UNITED STATES PATENT AND TRADEMARK OFFICE

APPLICATION NO.	FILING DATE	FIRST NAMED INVENTOR	ATTORNEY DOCKET NO.	CONFIRMATION NO.
10/075,371	02/15/2002	Kalyan Handique	10255-029-999	9738
26171	7590	08/23/2005	EXAMINER	
FISH & RICHARDSON P.C. P.O. BOX 1022 MINNEAPOLIS, MN 55440-1022			SINES, BRIAN J	
			ART UNIT	PAPER NUMBER
			1743	
DATE MAILED: 08/23/2005

Office Action Summary

DETAILED ACTION

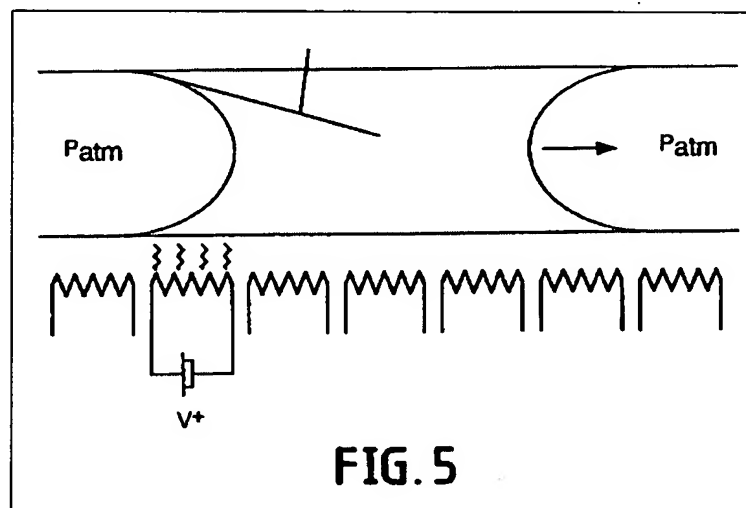
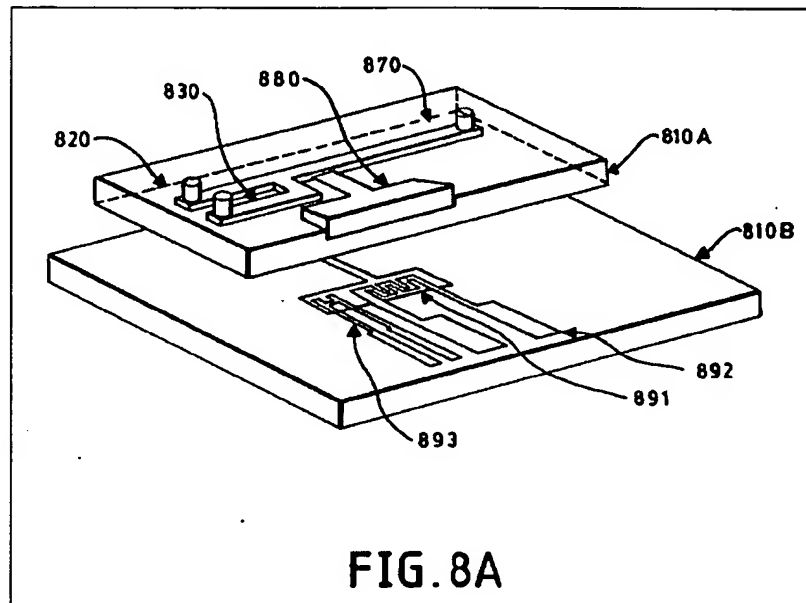
Regarding claims 1 – 4, 12, 18, 19, 30 & 31, Handique teaches a microfluidic apparatus comprising: first (810A) and second (810B) planar substrates; a microfluidic network (e.g., channels & chambers located in glass substrate 810A); a gas vent (870); and a first gas actuator comprising air chamber 880 located in the first substrate and heater 891 located in the second substrate 810B. The glass substrate (810A) is bonded or sealed to the silicon substrate (810B) (see figure 8A; col. 20, lines 5 – 14). Handique teaches the incorporation of a hydrophobic region within the gas vent (70) (see figure 3A; col. 14, lines 44 – 50). Handique teaches the incorporation of a processor or controlling circuitry with the disclosed microfluidic apparatus (see col. 4, lines 4 – 10+). The Handique apparatus illustrated in figure 8A below appears to be equivalent to the applicant's apparatus shown in figure 2 of the applicant's disclosure, although

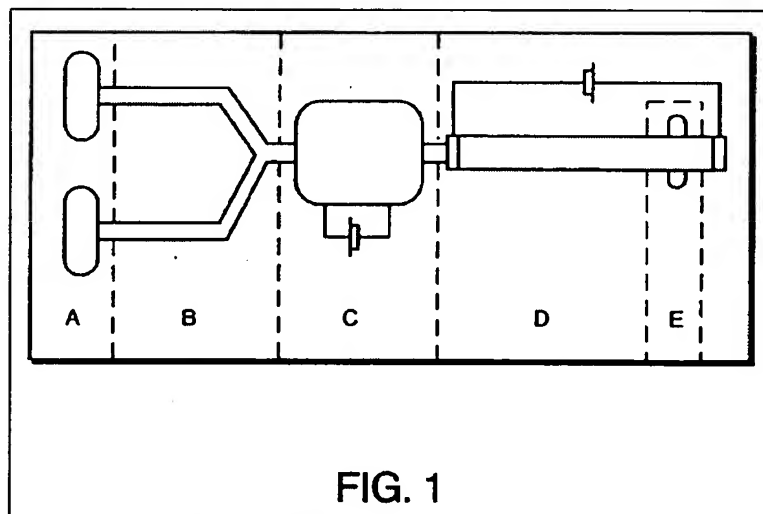
differing in the number of heating elements and gas actuators. As shown in figure 5, Handique teaches the further incorporation of successive gas actuators, which comprise the heaters, along a channel in order to facilitate fluid transport through the channel (see col. 15, line 41 – col. 16, line 23; figure 5).
